# AG-MI-2014-06-C-EN -Crimp Connection Relay Cable

MTOsport serial numbers M01173 up to and including M01217 and MTOsport, which are retrofitted with main fuse attachement kit - retrofit kit (M.EL452 / after 07.08.2014)

Fig. 1 - Main fuse carrier

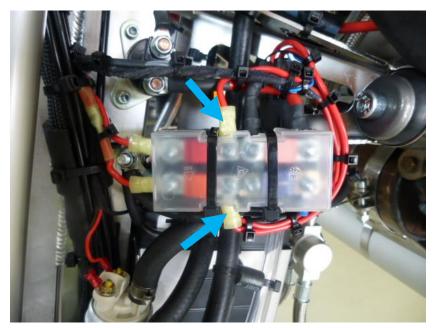
Within Quality checks an inaccurate crimp connection was found on the crimp connector joining the cable from the regulator relay to the fuse box

Inspect crimp connection and replace following cables if necessary:

- Main fuse carrier relay (see Fig. 1)
- Relay main fuse carrier (see Fig. 1)

- 1 Inspect crimp connection of cables marked in Fig. 1 (Accord: Fig. 2 and 3)
- 2 If crimp connection is wrong, then:
- 3 Open main fuse box by removing cable ties
- 4 Disconnect affected cable(s) from fuse and relay,release affected cable(s) by removing cable ties, replace affected cable(s) by new part(s)
- 5 Assembly in reverse order
